RE: 2018-363 - Planning & Environment - Notification of Modification (SSD 7317 MOD 12)
Australian Technology Park

Please be advised after reviewing the proposed Notification of Modification (SSD 7317 MOD 12)
Australian Technology Park

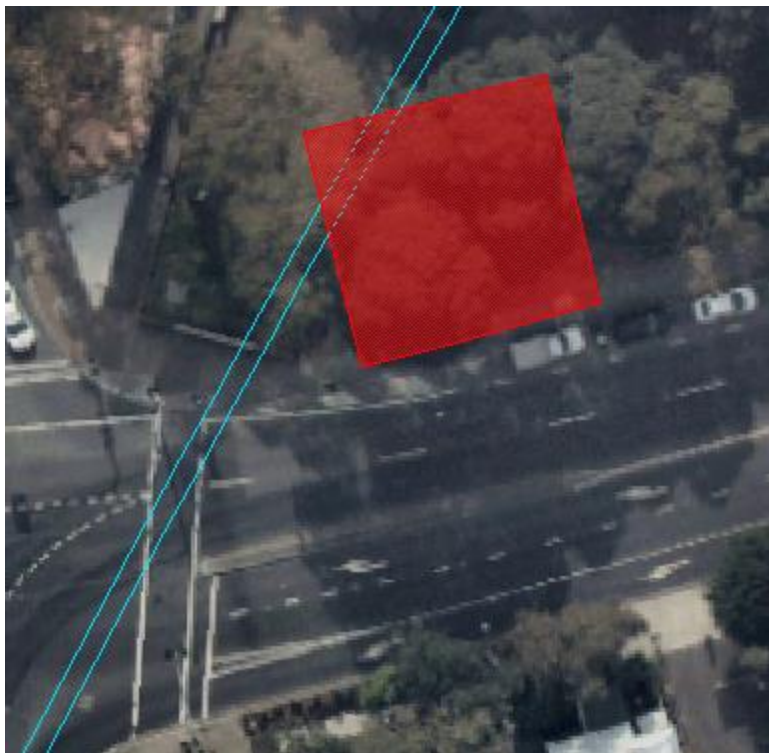
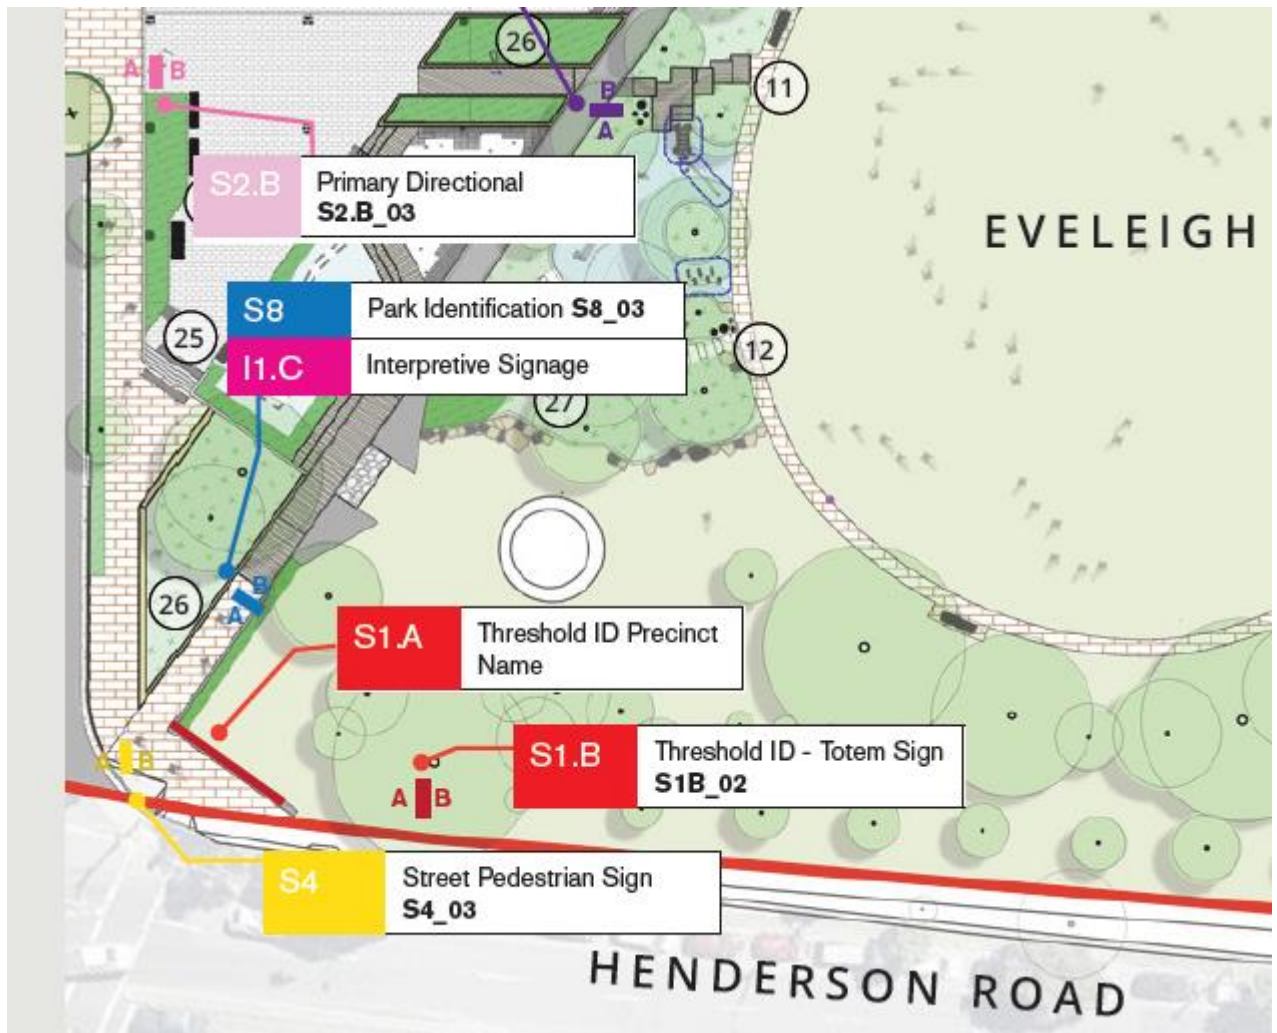
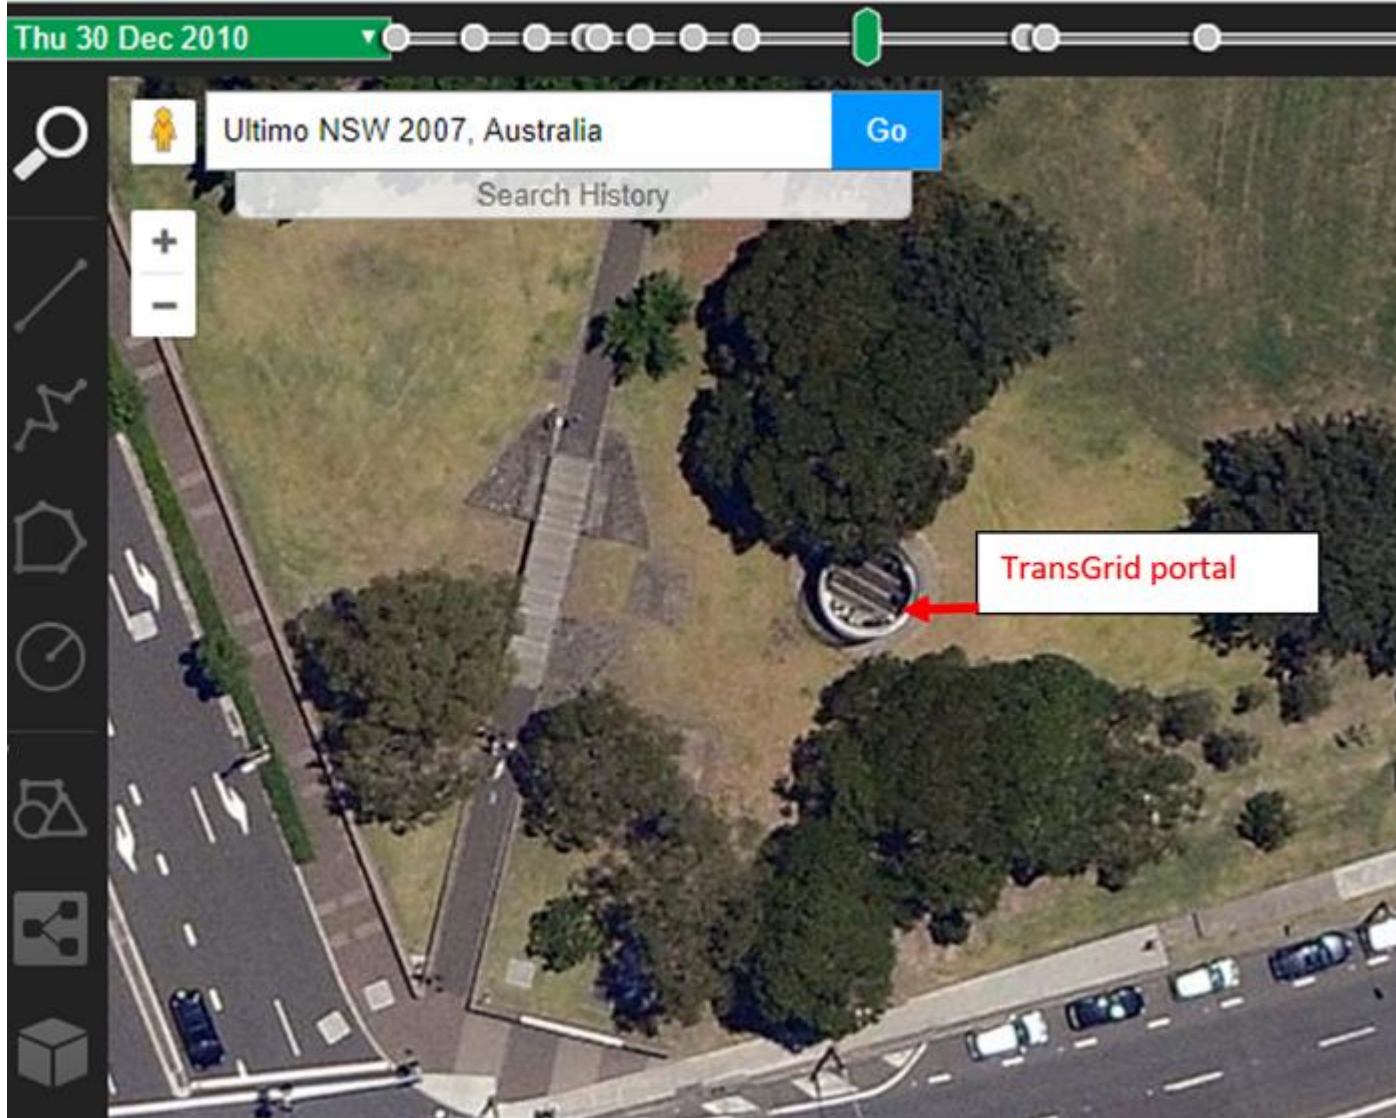
1. TransGrid **must** be able to maintain access to their portal in Australia Technology Park. Over the years these has been increasing vegetation growth narrowing access.
2. The proposed totem signage S1.B (screenshots below) is located in the access easement acquired for maintenance of the portal. It looks like it may impede access/egress and use of that area between the tree and the footpath for maintenance vehicle parking.
3. **TransGrid requests that the maintenance access requirements and easement be considered as part of the masterplan.**
4. The current access point to the tunnel portal being off Henderson St (near Davy Rd)
5. Vehicular travel to the tunnel portal is currently still possible within the grounds.
